CGL4703-CGP-BCEAO-REG-LTR-4953

Re: Coastal GasLink Pipeline Project (Project)

Inspection Record IR2021-027 Opportunity to Respond Environmental Assessment Certificate (EAC) #E14-03 October 14 to 21, 2021 Project wide inspection

Photo 3: Parsnip MUS - Covered lubricant and antifreeze storage.

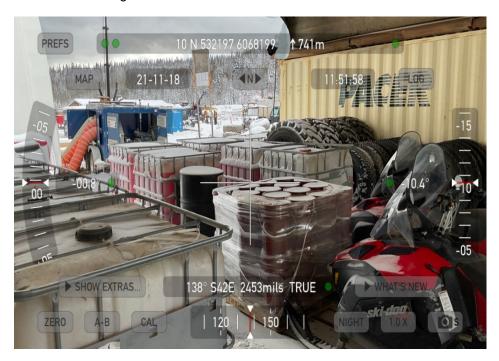
The bulk oils e.g. hydraulic and motor oil and antifreeze identified in IR2021-027 Photo 27 are now stored in a covered storage area.
